Form 504 U. S. DEPARTMENT OF COMMERCE COAST AND GEODETIC SURVEY DESCRIPTIVE REPORT	
<i>Type of Survey</i> SHORELINE (Photogrammetric)	
<i>Field No.</i>	<i>Office No.</i> T-12183
LOCALITY	
<i>State</i> ALASKA	
<i>General locality</i> KEKU STRAIT	
<i>Locality</i> CAPE BENDEL	
<hr/> 19 62-1966	
CHIEF OF PARTY	
Alfred C. Holmes, Director, AMC	
LIBRARY & ARCHIVES	
DATE

REVIEW REPORT T-12183

ADDENDUM TO REVIEW REPORTS

T-12183

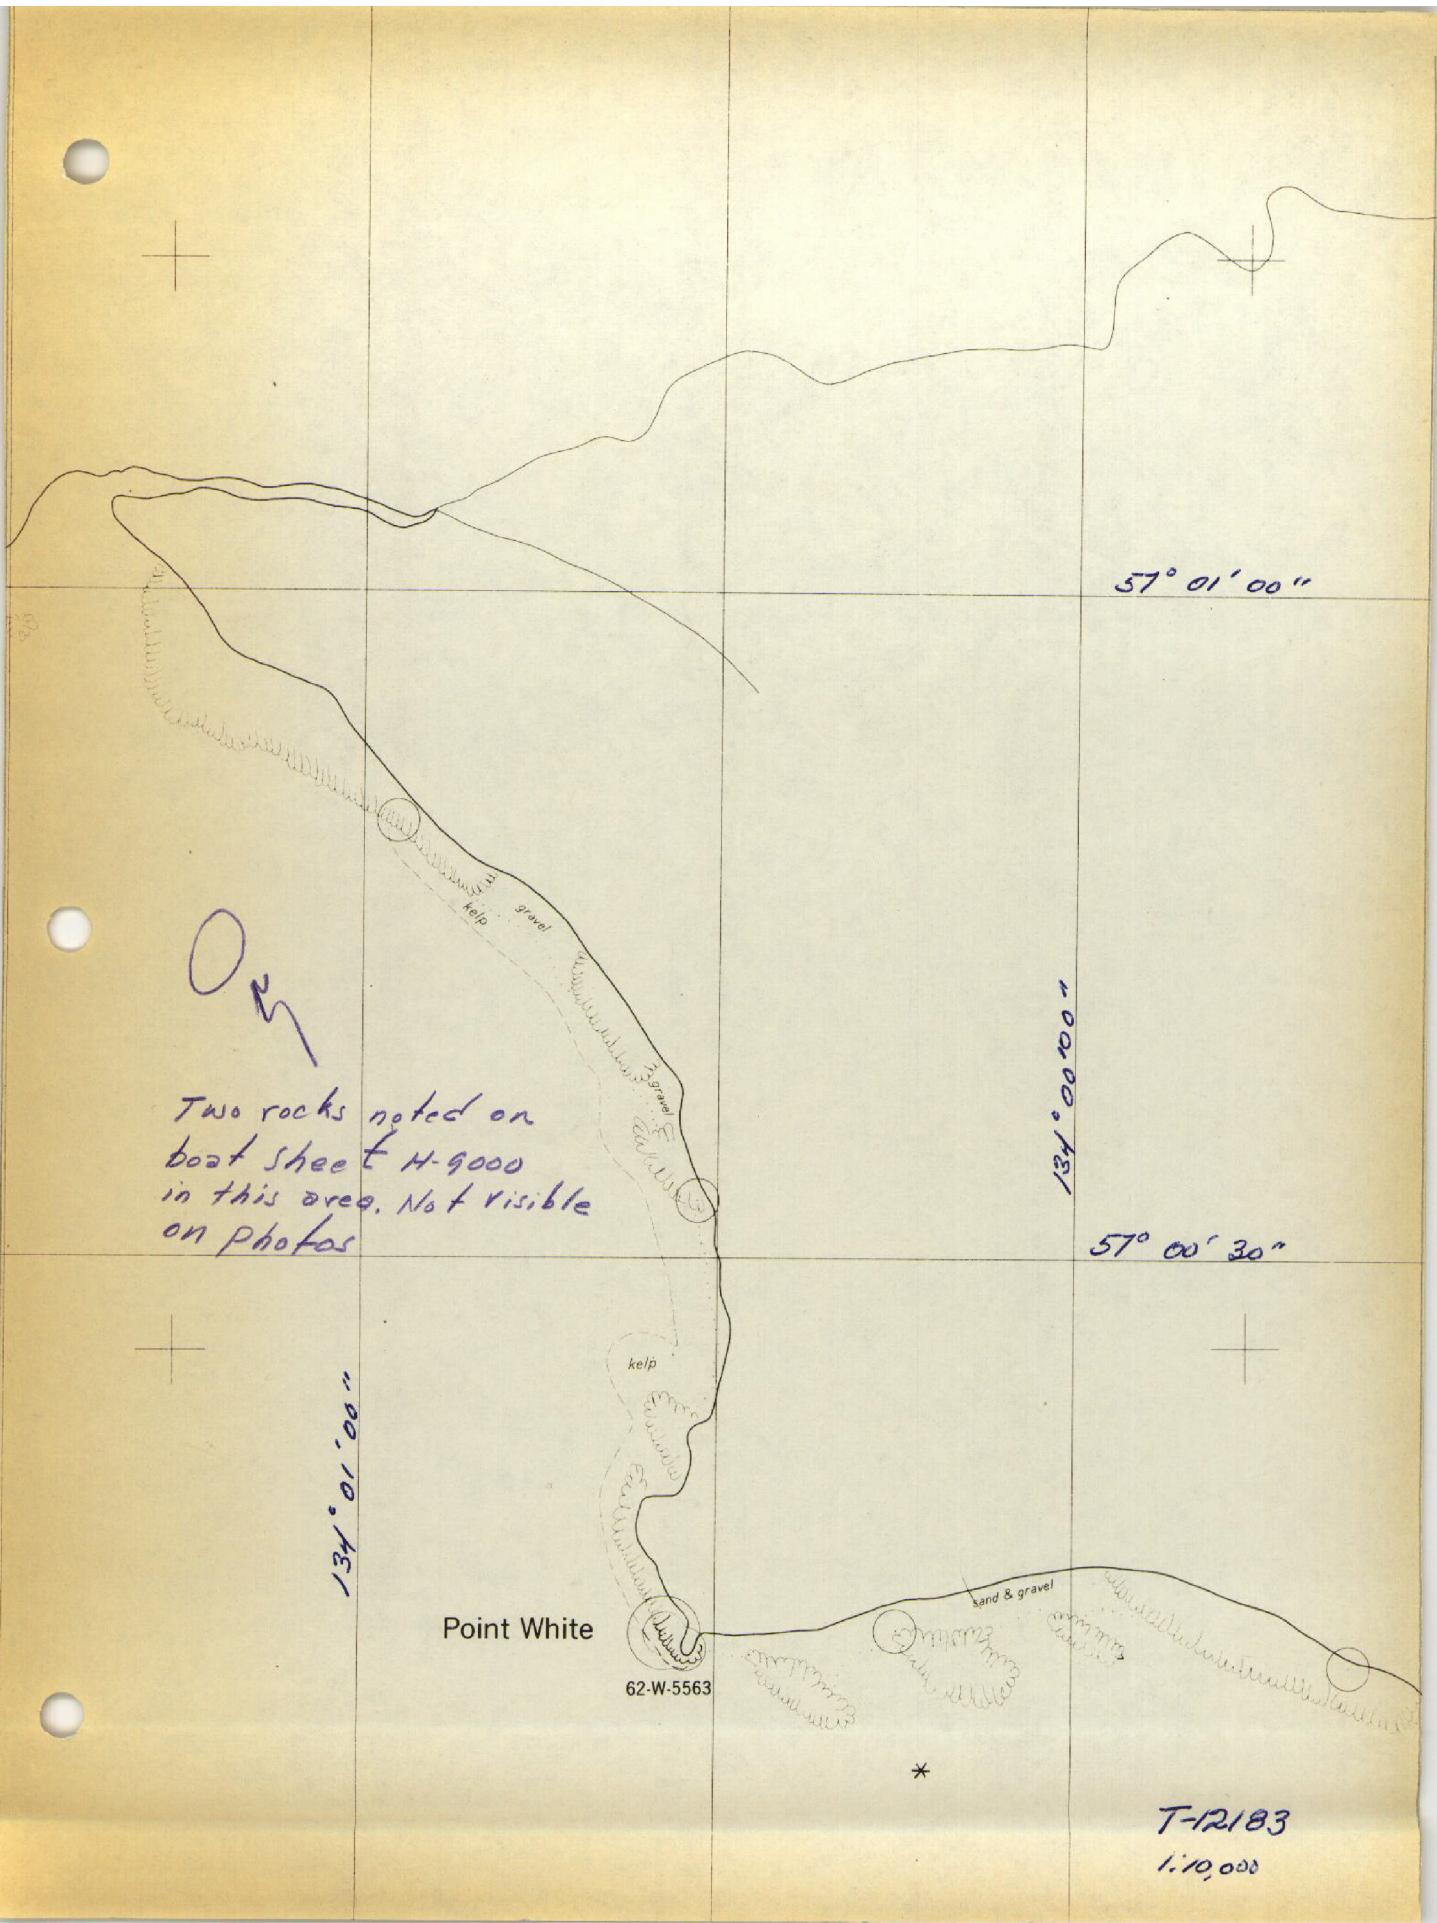
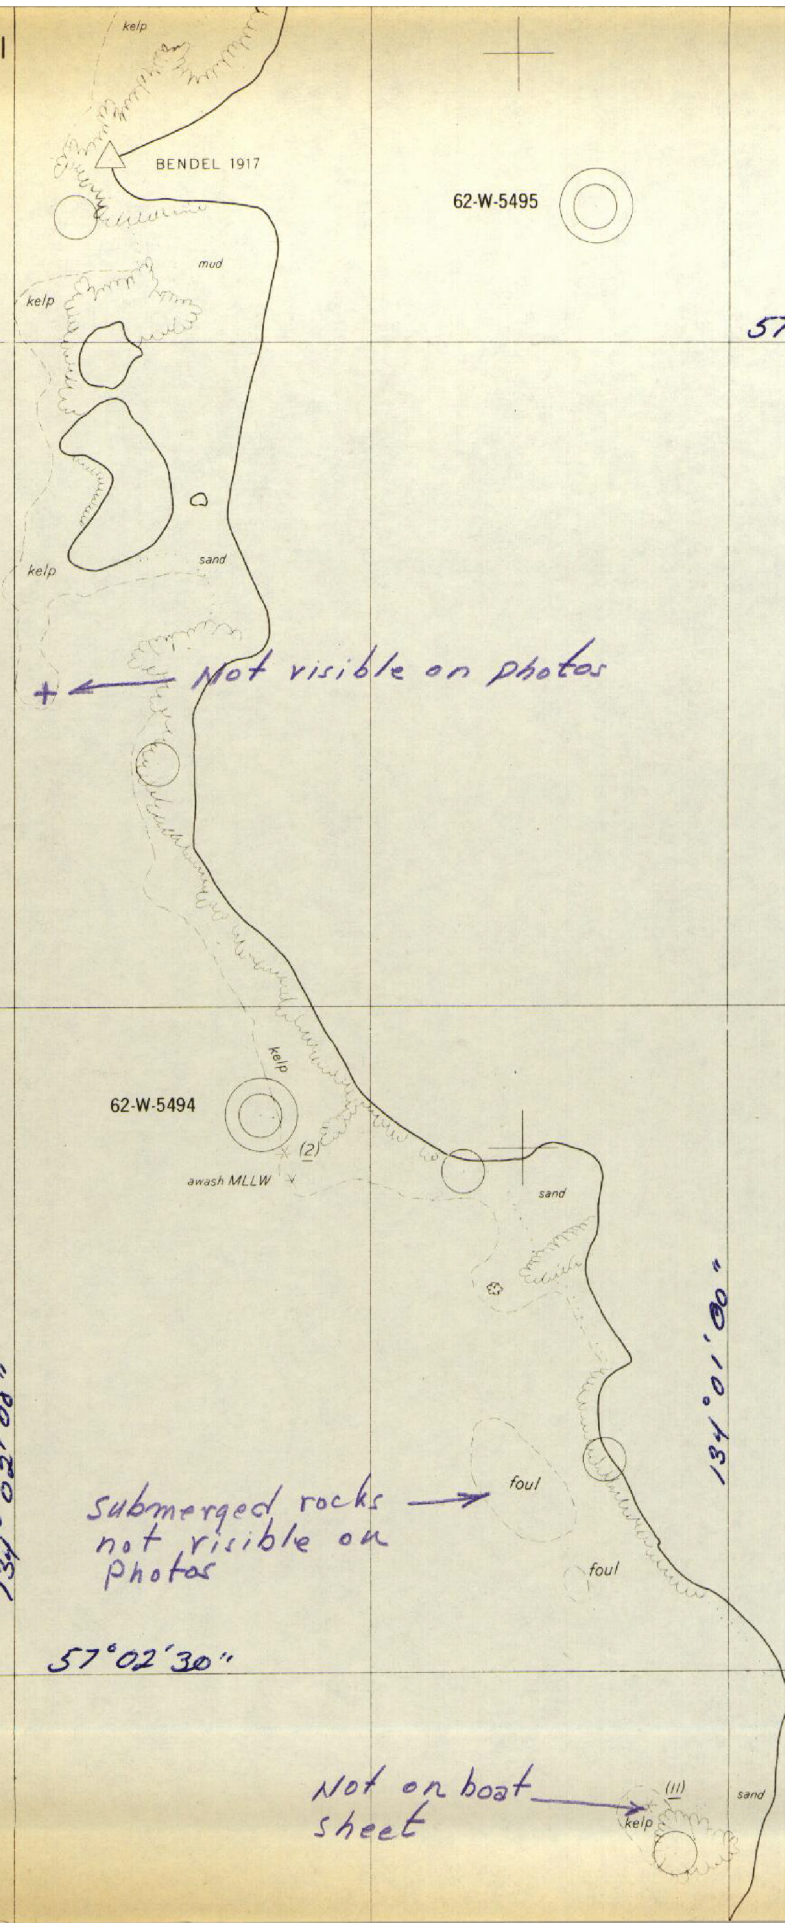
+ ← Not visible on photos

Submerged rocks
not visible on
photos →

Not on boat
sheet →

Rocks in purple from H-8907

Pt. Macartney Lt
not visible on photos;
not mapped on T-12183

Rock not on
boat sheet

Rock not visible on
photos

* ← Not visible on
photos
